ADDENDUM # 2

RFQ #7479364

Title: CCRI Flanagan Campus Library Interior Renovations

This Addendum forms a part of the Contract Documents and modifies the Drawings and Project Manual as hereinafter indicated.

Project Number: 058
 Drawing No: A801
 Sheet

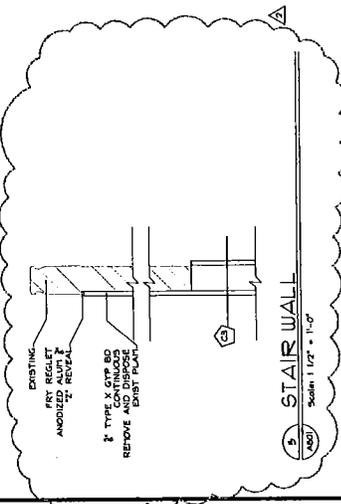
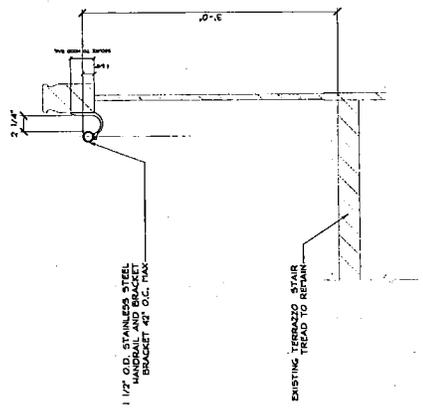
Question: Can we use 12 inch CMU insulated block instead of 8 inch and 4 inch block?

Response: *There is no CMU work on this project. Refer to wall types on drawing A801.*
